DATE ~~R~~ Aug.20/02**V2500-A5/D5 PROPULSION SYSTEMS SERVICE BULLETIN**

This document transmits Revision 1 to Service Bulletin EV2500-72-0405 and  
 Revision 1 to the Supplement

**V2500-ENG-72-0405**  
 Transmittal - Page 1 of 2

ENGINE – PROVIDE NEW NUMBER FOUR BEARING FRONT AND REAR SEALS

Front and rear seat No.4 bearing seal  
Fig 1

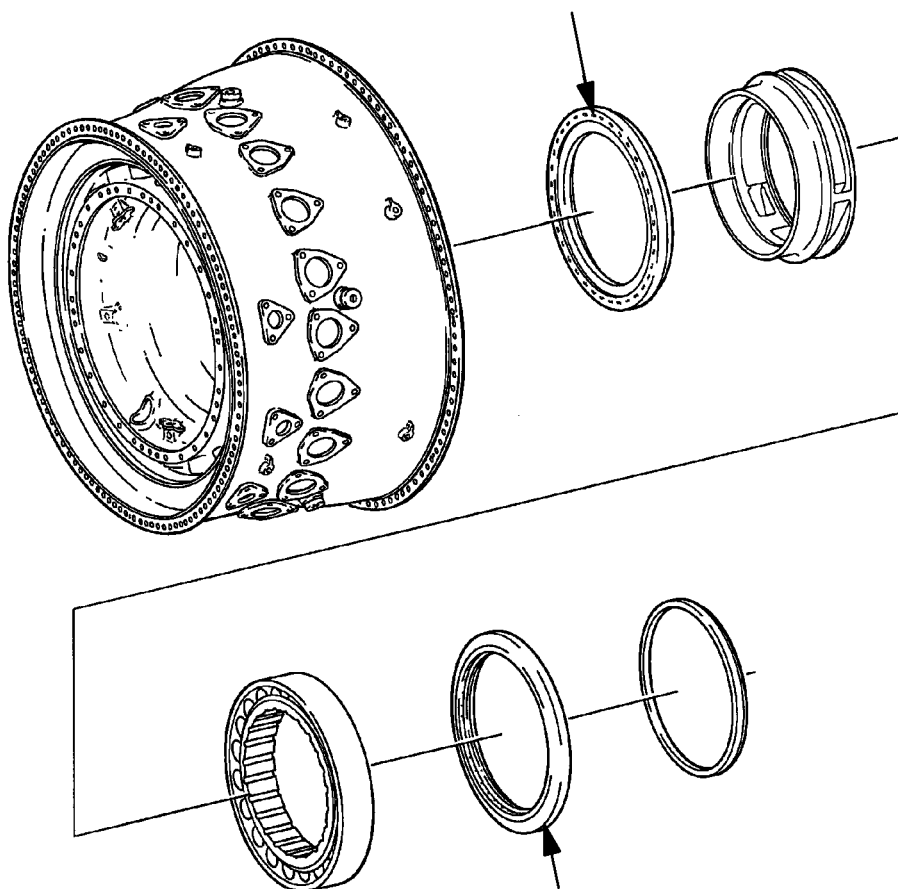
REPLACE SEAT NO. 4 BEARING  
SEAL FRONT PN 2A0066 OR  
2A1998 WITH 2A3432

REPLACE SEAT NO. 4 BEARING  
SEAL REAR PN 2A0067 OR  
2A1999 WITH 2A3433

Family tree – Front and rear seat No.4 bearing seal (V2500-A1) Ref catalog sequence  
No. 72-43-11 Fig 01 item 010 and 72-43-14 Fig 01 item 020  
Fig 2

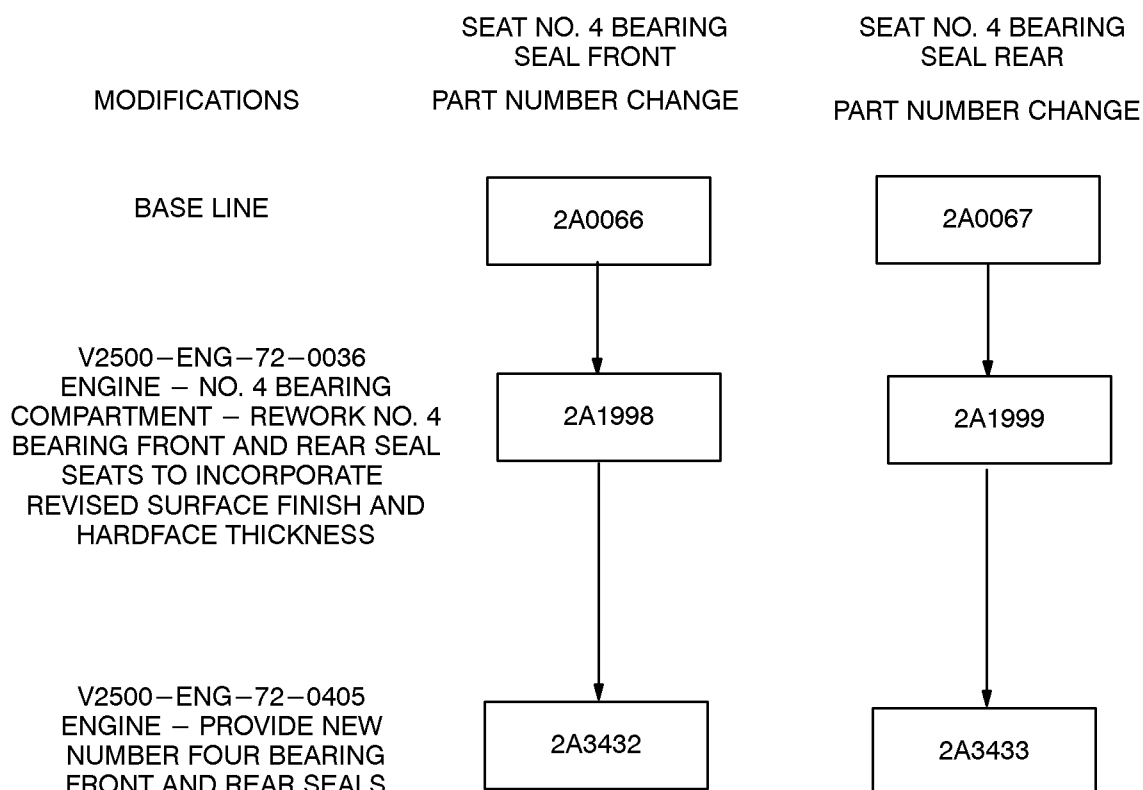
Figs 2 and 3 Parts Progression To Show the Changed Part in Relation to Other Parts
